Access Compliance Report

Public Rights-of-Way

(Curb Ramps)

Intersection ID: 16161	Main Street: E_INDEPENDENCE_BV	Cross Street: CHARLESTON DR	Location: E
ADA ID: CDEF31A3BCB0	Ramp Type: Perp	Initial Pass/Fail: Fail	Overall Compliance: No
			Severity Score: 21.25

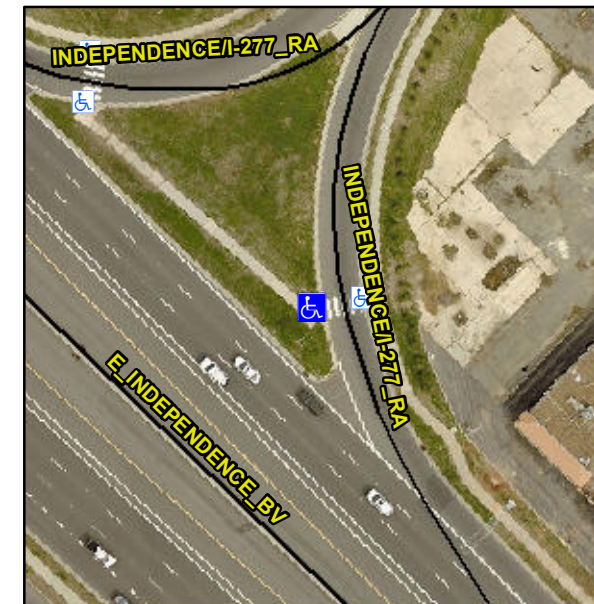
R304.5.1, R304.2.2

Compliance	Description	Data	Compliance	Description	Data
N/A	Ramp Length (in)	73.0	No	Ramp Slope (%)	10.3
No	Ramp Width (in)	47.5	Yes	Ramp XSlope (%)	1.6
N/A	Flare Type LT	N/A	N/A	Flare Type RT	N/A
N/A	Flare Slope LT (%)	N/A	N/A	Flare Slope RT (%)	N/A
N/A	Flare Traversable LT?	N/A	N/A	Flare Traversable RT?	N/A
N/A	Landing Length (in)	N/A	N/A	DWS Provided?	N/A
N/A	Landing Width (in)	N/A	N/A	DWS Contrast?	N/A
N/A	Landing Slope (%)	N/A	N/A	DWS Length (in)	N/A
N/A	Landing X Slope (%)	N/A	N/A	DWS Full Width?	N/A
N/A	Landing Curb? (Y/N)	N/A	N/A	DWS Offset (in)	N/A
N/A	Shared Landing?	N/A			
N/A	Gutter Ponding?	N/A	N/A	Gutter Slope (%)	N/A
N/A	Gutter Lip Ht (in)	N/A	N/A	Gutter X Slope (%)	N/A
N/A	Painted X Walk1?	Yes	N/A	Painted X Walk2?	N/A
	X Walk 1 Direction	To E		X Walk 2 Direction	N/A
N/A	X Walk 1 Width (in)	119.0	N/A	X Walk 2 Width (in)	N/A
	X Walk 1 Slope (%)	2.0		X Walk 2 Slope (%)	N/A
	X Walk 1 X Slope (%)	0.3		X Walk 2 X Slope (%)	N/A

Remove & Replace Entire Ramp.
